Enclosure
L-19-168

Perry Nuclear Power Plant EP 0000 Revision 53 Change Summary

Revision 53 of the Emergency Plan for Perry Nuclear Power Plant Docket No. 50-440 contained the following changes:

TITLE: EMERGENCY PLAN FOR PERRY NUCLEAR POWER PLANT DOCKET NOS. 50-440

FIGURE 5-1 - EMERGENCY RESPONSE ORGANIZATION (INTERIM PHASE)

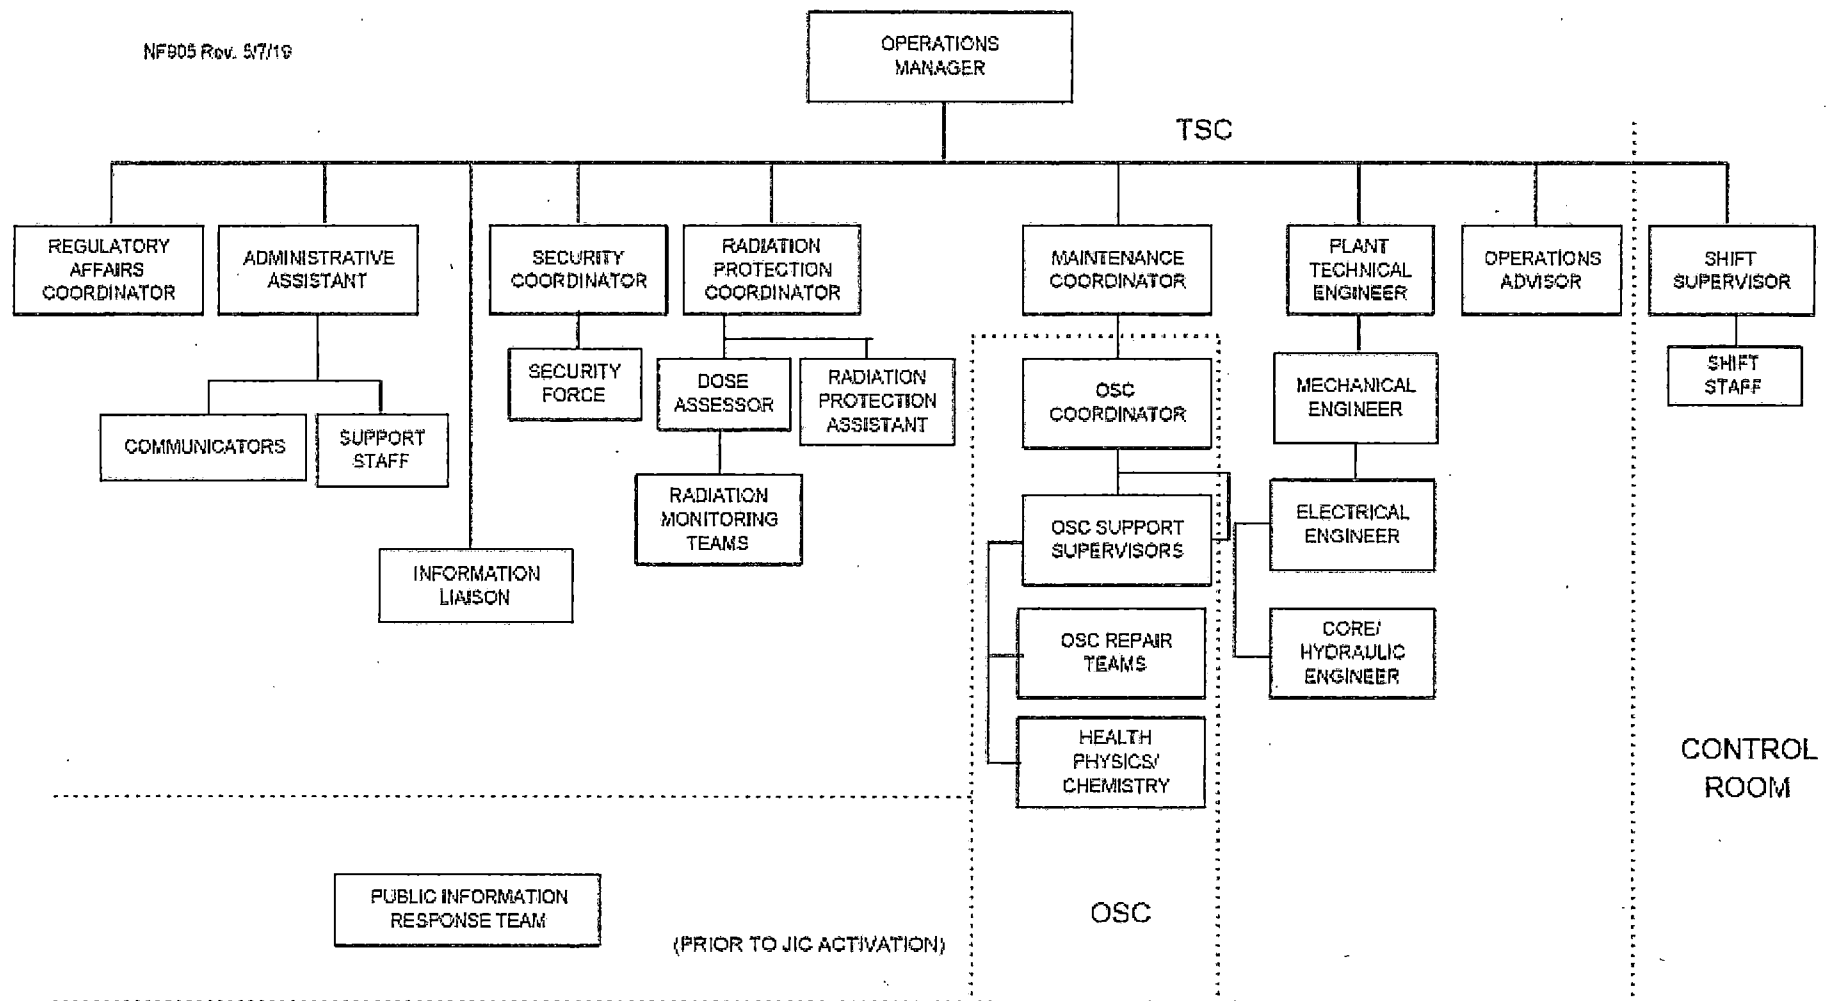
- a. Removed PIRT from Figure 7-4 to allow PIRT to be located at a location other than the EOF.
 - b. Removed EOF from Figures 5-1 and 5-2 to allow PIRT to be located at a location other than the EOF.

4. Removed Technical Engineering Staff from figures 5-1, 5-2 and 6-1 since the position is not required in staffing Tables 5-1a and 5-1b.
 - a. This position has no programmatic description in the Emergency Plan.

5. Removed Operations Liaison, System Analysis Engineer and Emergency Response Information System (ERIS) Operator from Figures 5-1 and 5-2 since the positions are not required in staffing Tables 5-1a and 5-1b.
 - a. These positions have no programmatic description in the Emergency Plan.

FIGURE 7-4 - EMERGENCY OPERATIONS FACILITY (EOF) LAYOUT

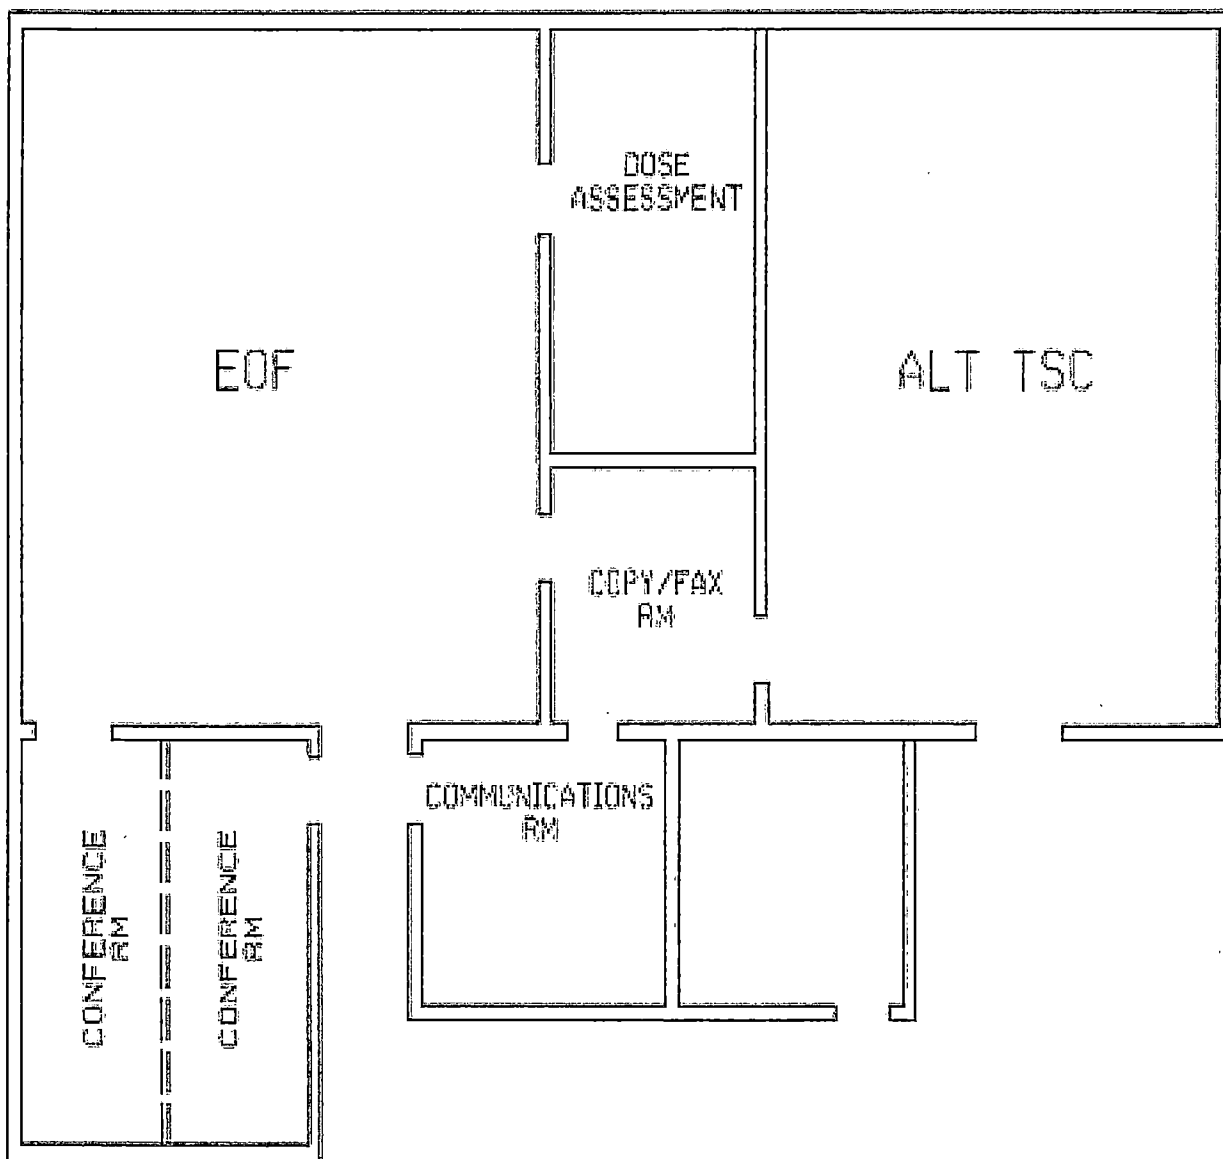
12. Removed PIRT from Figure 7-4 to allow PIRT to be located at a location other than the EOF.
 13. Removed EOF from Figures 5-1 and 5-2 to allow PIRT to be located at a location other than the EOF.
